Access Compliance Report Public Rights-of-Way (Curb Ramps)

Main Street: DRYSDALE_LN Cross Street: BASKERVILLE_RD Location: S

ADA ID: RPRK211215122126 Ramp Type: Type 1 - Perpendicular Diagonal Initial Pass/Fail: Pass Overall Compliance: No Severity Score: 12

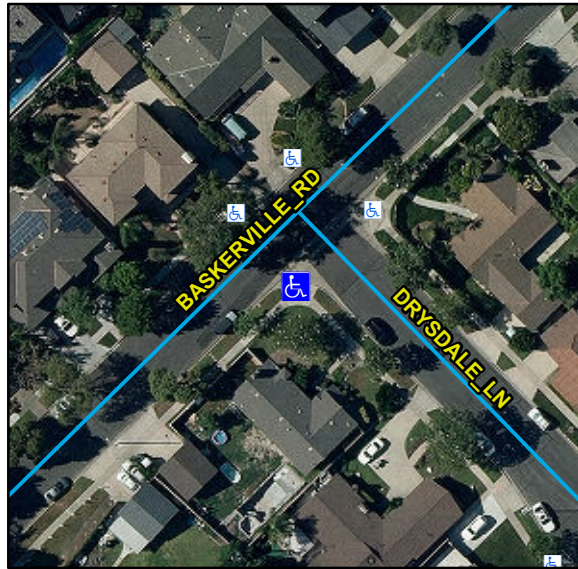
R204.3, R304.2.2-Perp, R304.3.2-Para, R305, STD 1115

Remove & Replace Curb Ramp With Two New Directional Ramps or Equivalent.
